# Access Compliance Report

## Public Rights-of-Way

### (Curb Ramps)

Intersection ID: 11499	Main Street: TIMBERTOP_LN	Cross Street: VERONICA_DR	Location: NW
ADA ID: D39A13B31926	Ramp Type: Perp	Initial Pass/Fail: Fail	Overall Compliance: No
		Severity Score: 10

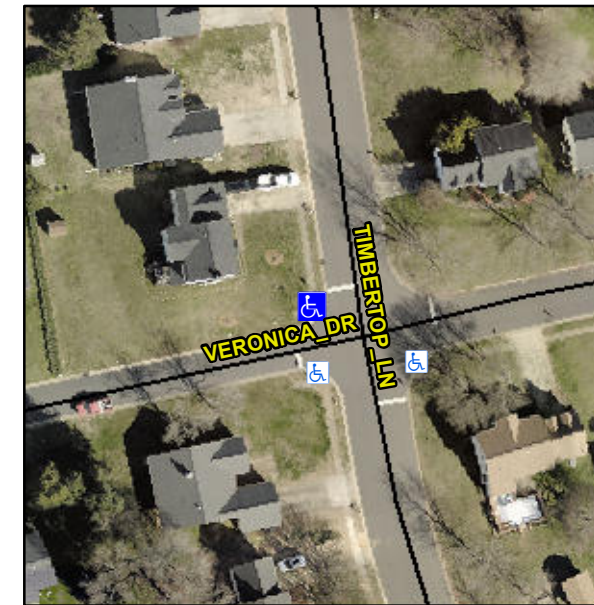
**R304.5.1, R304.5.3**

Compliance	Description	Data	Compliance	Description	Data
N/A	Ramp Length (in)	48.0	Yes	Ramp Slope (%)	6.8
No	Ramp Width (in)	42.0	No	Ramp XSlope (%)	4.4
N/A	Flare Type LT	N/A	N/A	Flare Type RT	N/A
N/A	Flare Slope LT (%)	N/A	N/A	Flare Slope RT (%)	N/A
N/A	Flare Traversable LT?	N/A	N/A	Flare Traversable RT?	N/A
N/A	Landing Length (in)	N/A	N/A	DWS Provided?	N/A
N/A	Landing Width (in)	N/A	N/A	DWS Contrast?	N/A
N/A	Landing Slope (%)	N/A	N/A	DWS Length (in)	N/A
N/A	Landing X Slope (%)	N/A	N/A	DWS Full Width?	N/A
N/A	Landing Curb? (Y/N)	N/A	N/A	DWS Offset (in)	N/A
N/A	Shared Landing?	N/A			
N/A	Gutter Ponding?	N/A	N/A	Gutter Slope (%)	N/A
N/A	Gutter Lip Ht (in)	N/A	N/A	Gutter X Slope (%)	N/A
N/A	Painted X Walk1?	No	N/A	Painted X Walk2?	N/A
	X Walk 1 Direction	To S		X Walk 2 Direction	N/A
N/A	X Walk 1 Width (in)	N/A	N/A	X Walk 2 Width (in)	N/A
	X Walk 1 Slope (%)	2.0		X Walk 2 Slope (%)	N/A
	X Walk 1 X Slope (%)	4.6		X Walk 2 X Slope (%)	N/A

**Remove & Replace Entire Ramp.**
